STANDARD DEPARTURE CHART -INSTRUMENT

RJOF / HOFU SID

HOFU REVERSAL THREE DEPARTURE

INSTRUMENT APPROACH CHART

TACAN A

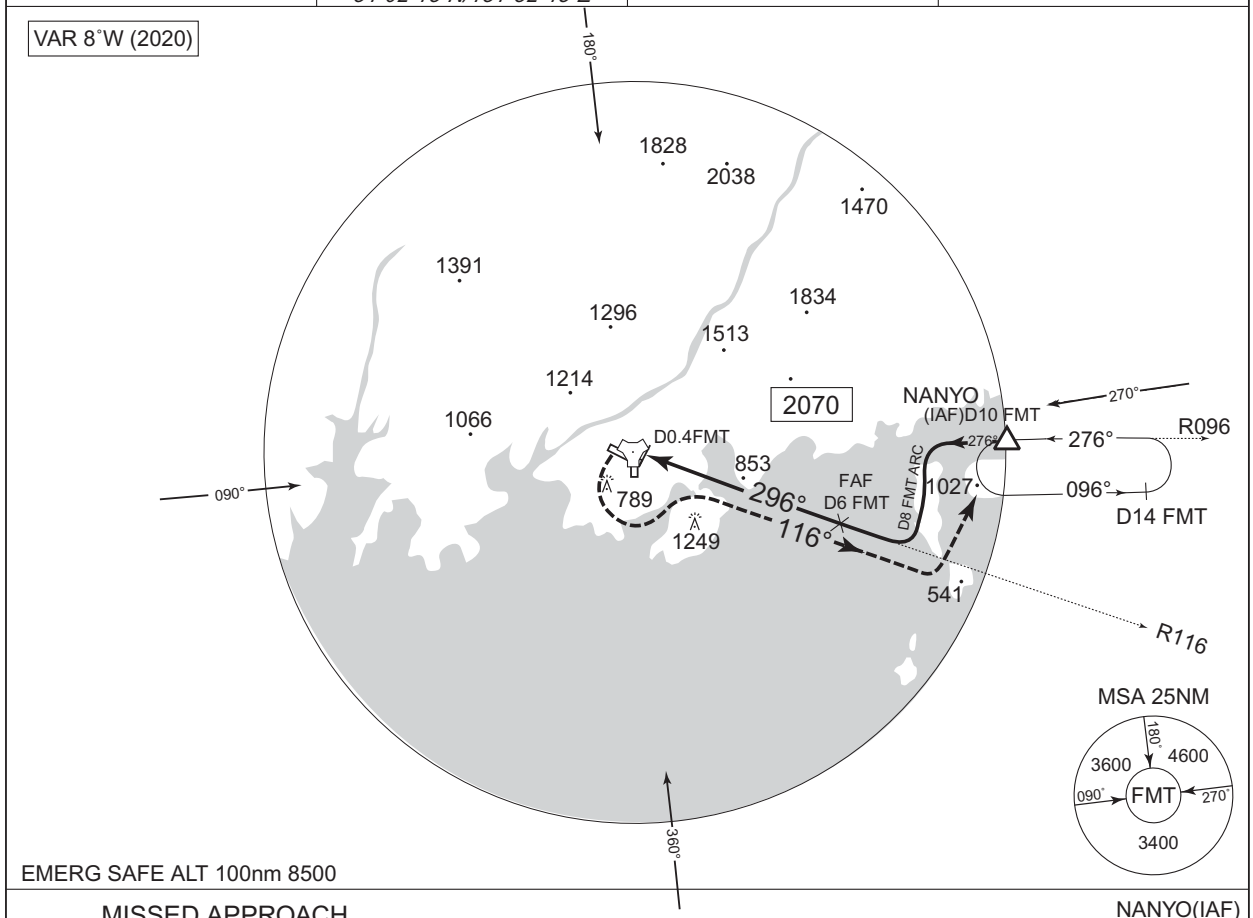
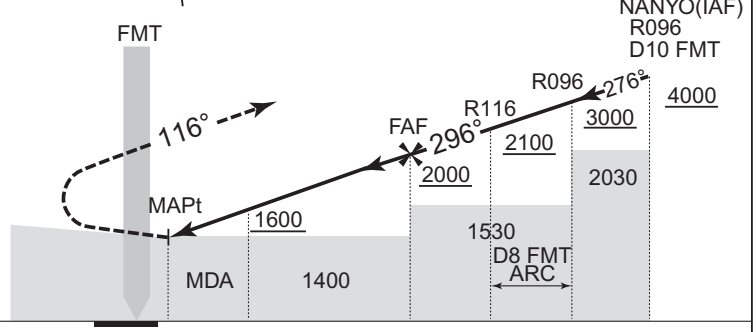
CHANGE : OBST.ALT restriction. OCA(H). MINIMA.
